700-718 HEIDELBERG ROAD ALPHINGTON

TOWN PLANNING ISSUE FOR CONSULTATIVE CONFERENCE

**YARRA PLANNING SCHEME
PLANNING APPLICATION NO: PLN17/0040
PROPOSAL: APARTMENTS
ADDRESS: 718 HEIDELBERG ROAD ALPHINGTON**

TO: Amy Hodgen
cc:
FROM: Euan Williamson, ESD Advisor
DATE: 17.01.2018
FILE: PLN17/0400 – 700-718 Heidelberg Road, Alphington
SUBJECT: ESD response to updated plans and SMP (re-issued)

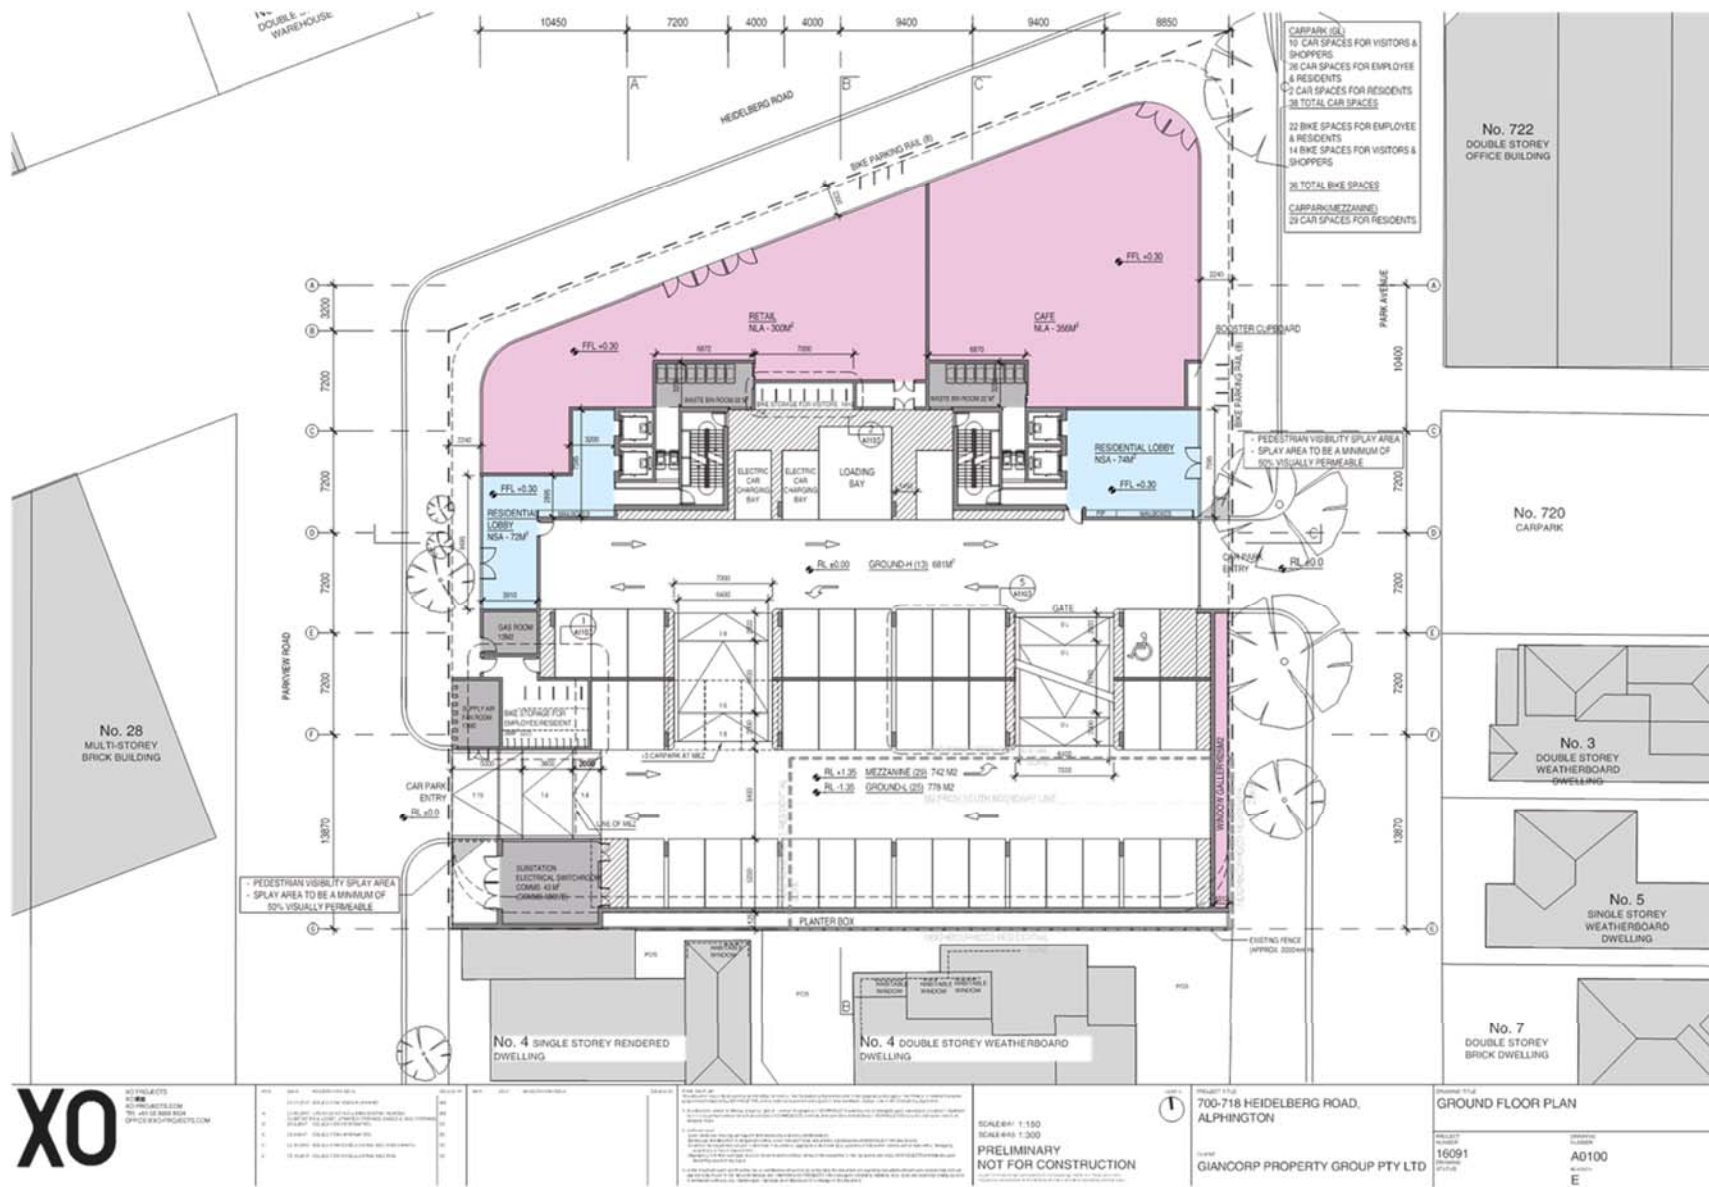
- We note that on the ground floor plan (drawings A0100-Rev A) the entrance to the proposed northeast corner café has not been indicated. If an external entrance to the café is proposed, then depending on its location, wind conditions would be expected to be between the standing comfort and walking comfort criterion as indicated in Figure 7 from the desktop assessment. Additionally if there is a potential for outdoor seating (not shown on the drawings), then wind conditions for outdoor seating area would need to be reassessed.

Figure 3 Landscape Concept Plan Roof Level Garden
7 700-718 Heidelberg Road, Alphington Landscape Report

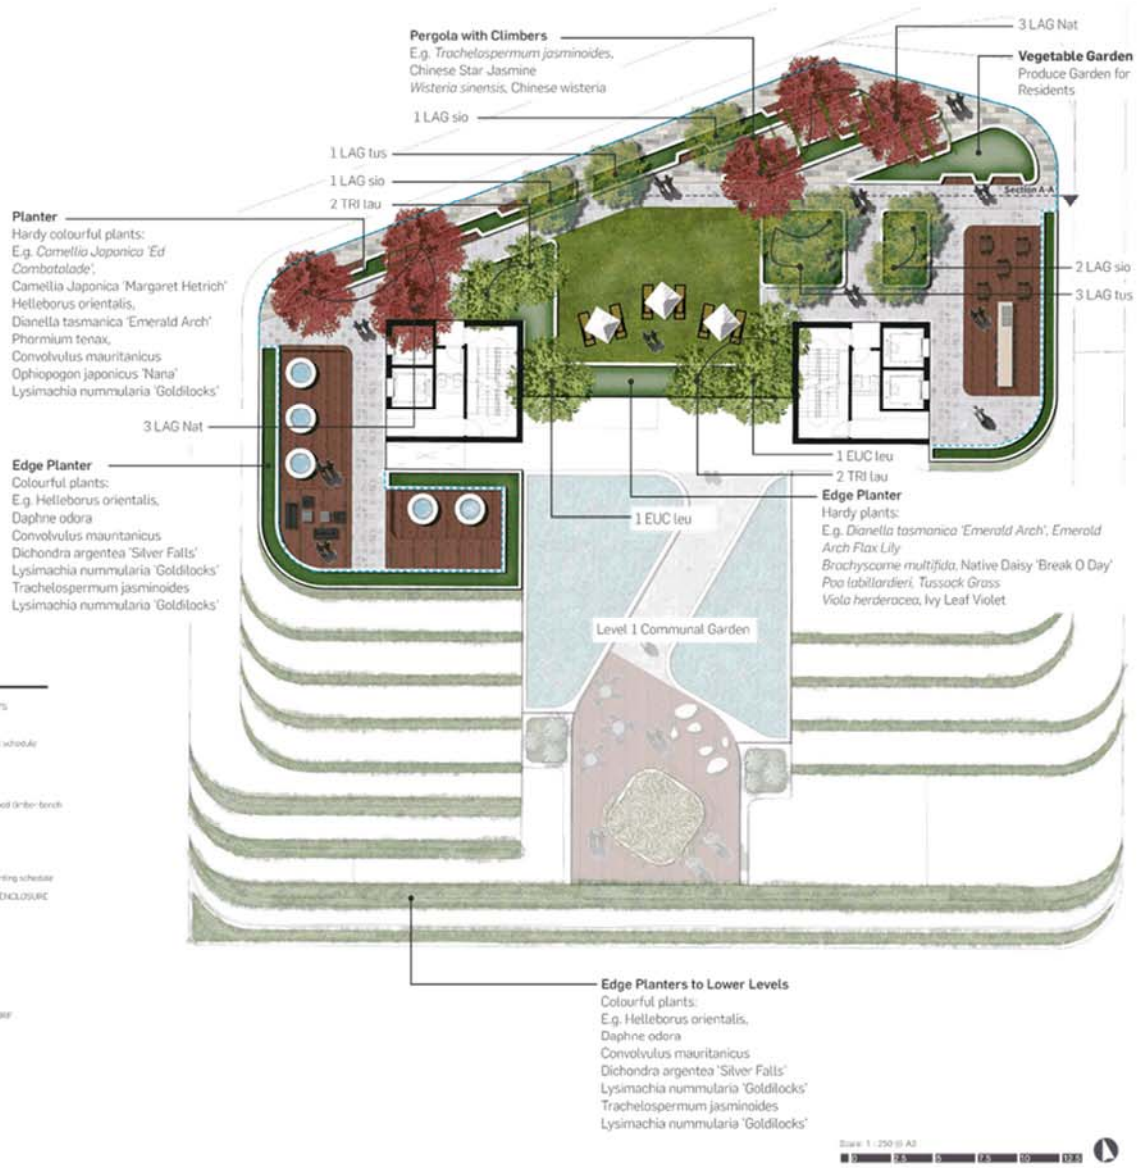
- We agree that the rooftop level with 1.6 m high glazed balustrades would achieve the criterion for walking comfort wind conditions on the outdoor communal terrace and localised porous screens around seating area would mitigate wind conditions to achieve the standing/seating criteria. However, being on the rooftop, the proposed pergola over the shaded blue region in Figure 8 of the desktop assessment would not be expected to mitigate wind flow rolling off over the top of the balustrades for wind directions that approach the balustrades at an angle. Therefore, we would expect that additional wind-break screens around that area would be required for wind conditions to achieve the sitting comfort criteria.
